1. SUBMITTAL TYPE: (Is this a resubmittal? Yes ☐ No ☒)			
Deferred Submittal ☐	Addendum Number: 01	Revision Number:	CCD Number: Category A ☐ or B ☐
2. PROJECT INFORMATION:			
School District/Owner: San Beranrdo City USD		DSA File Number: 36 H7	
Project Name/School: Indian Springs HS - Health Center		DSA Application Number 04 123900

ADDENDUM NO. 1

Indian Springs High School – Health Center

DSA #04-123900 FILE #36-H7 RCA Project No. 1-78-50

WALL SECTION 2
SCALE: 1/2" = 1'-0"

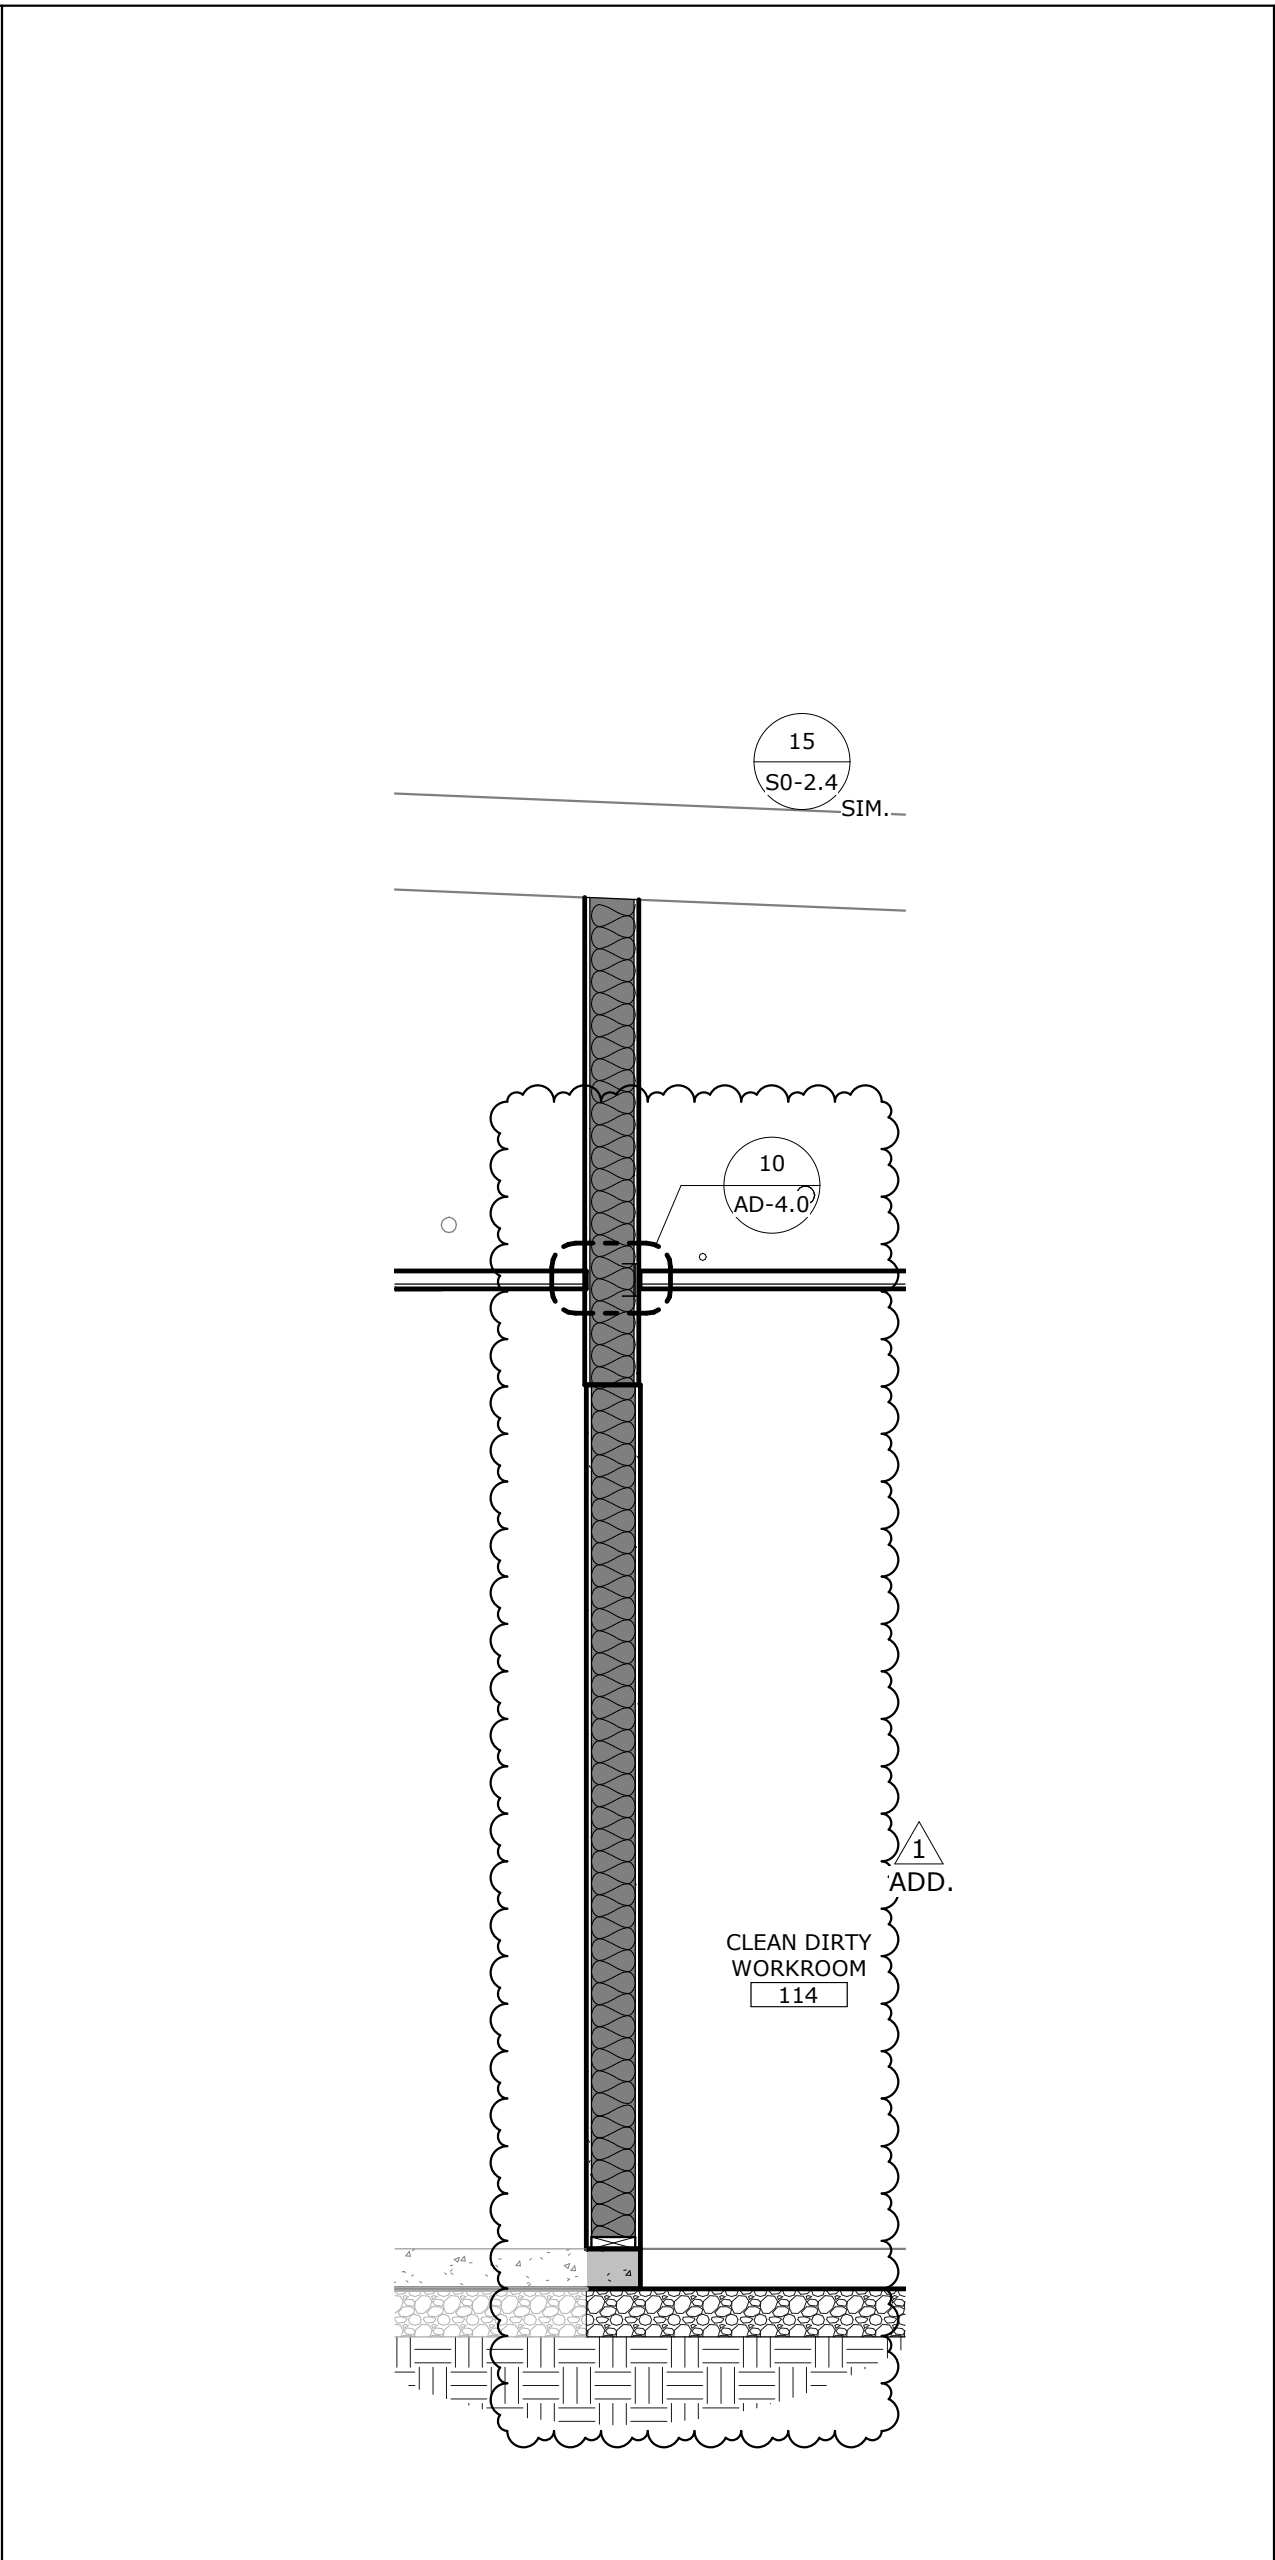
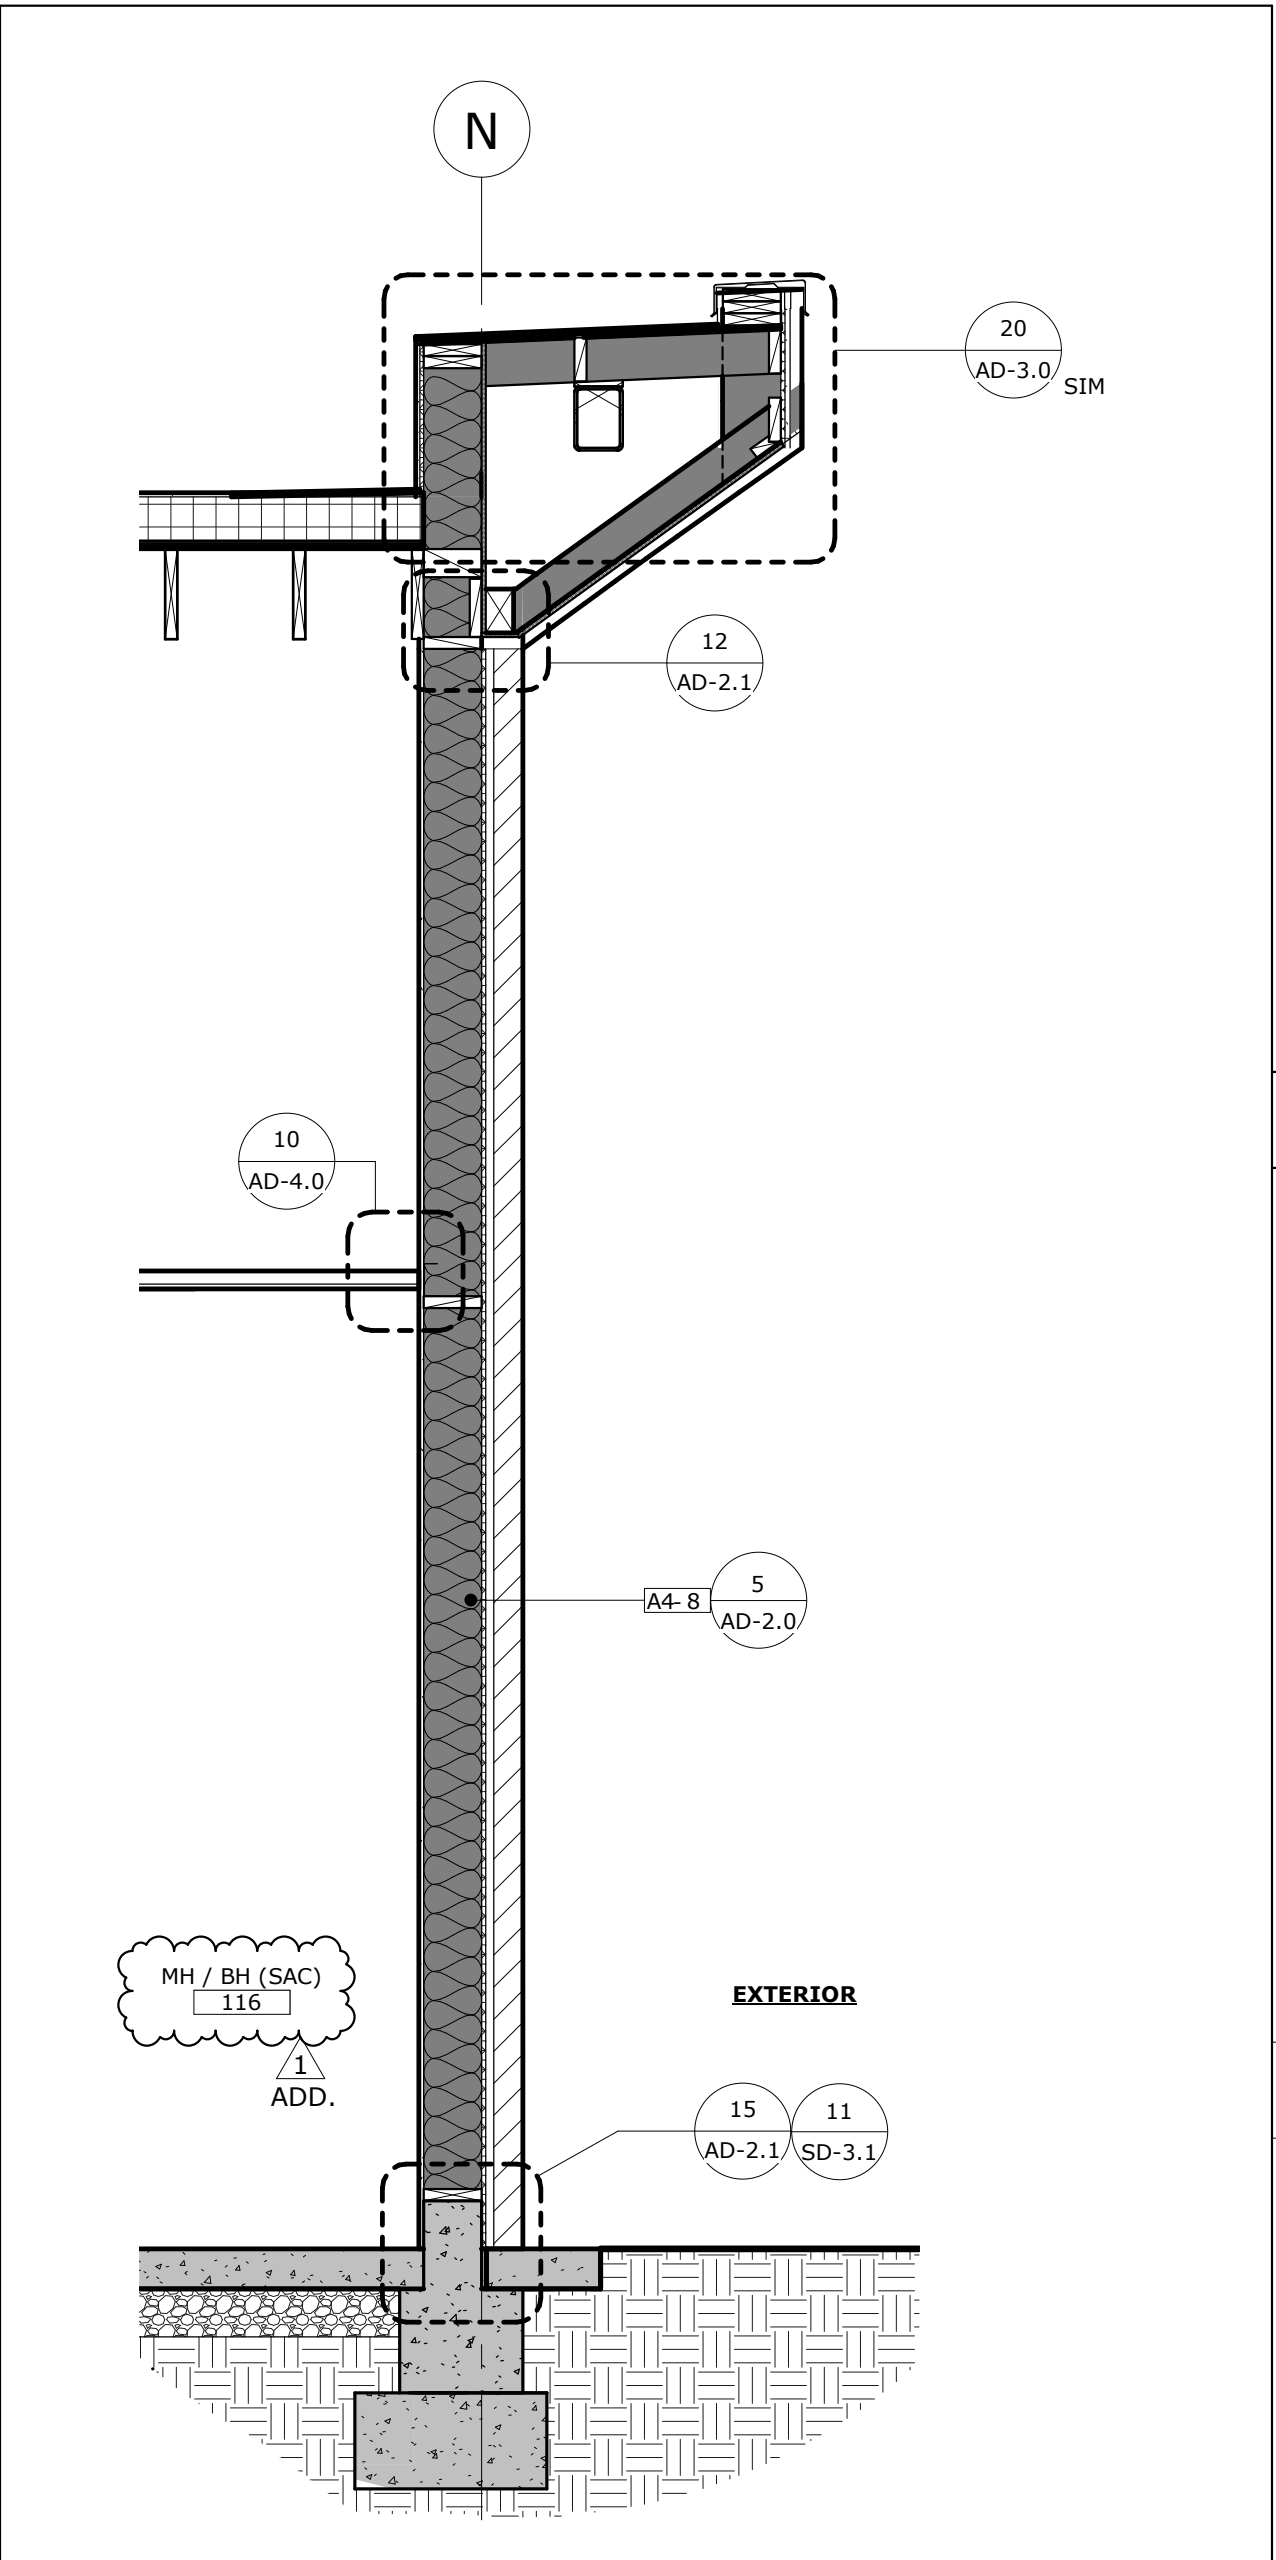
- Item No. 1.13 Reference Sheet A1-6.0 – WALL SECTIONS
1.13.1 Replace Sheet A1-6.0 and revise per clouded areas
- Item No. 1.14 Reference Sheet A1-7.0 – ENLARGED PLANS / INTERIOR ELEVATIONS
